ADDENDUM 4
RESCUE 8 STATION
Dated; 11-9-16

Requests for Information

18 SECTION @ VANITY

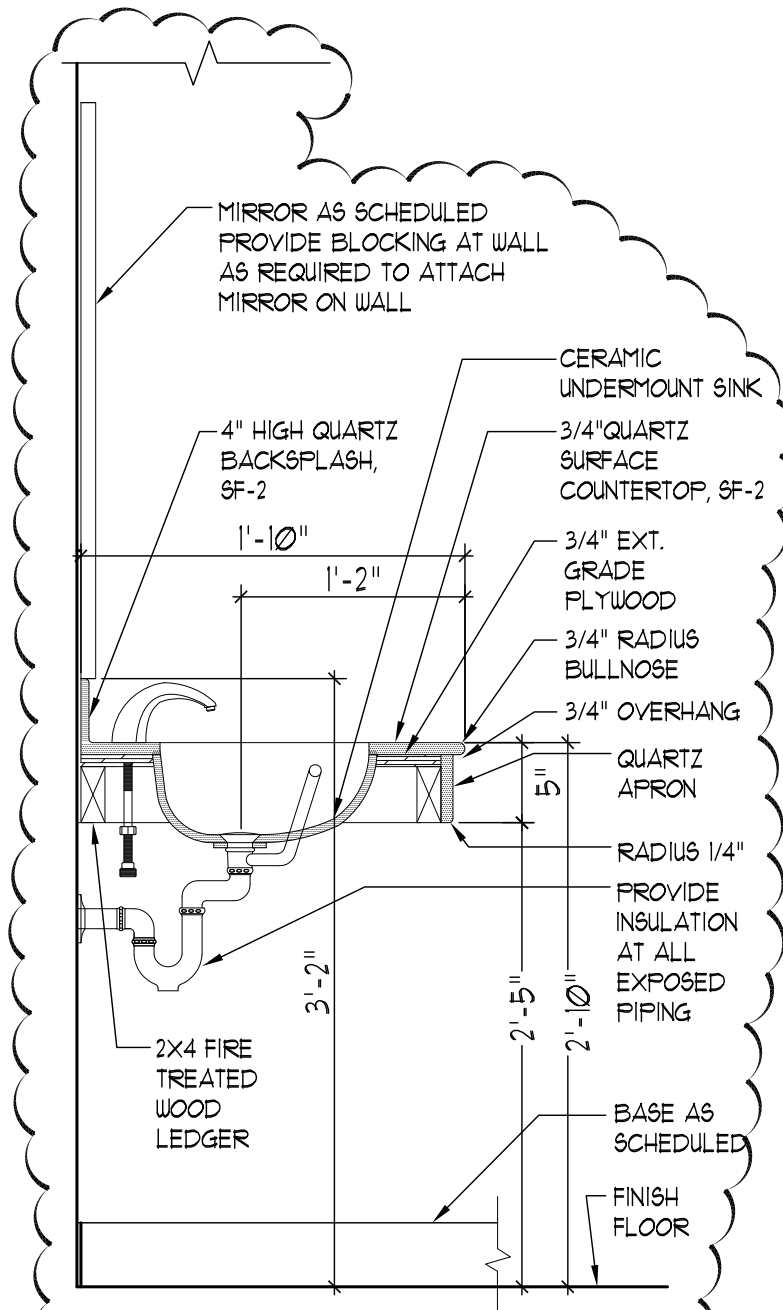
A detail for the vanity counter has been added to the project (18/A6.1). See attached sketch ASK-2.
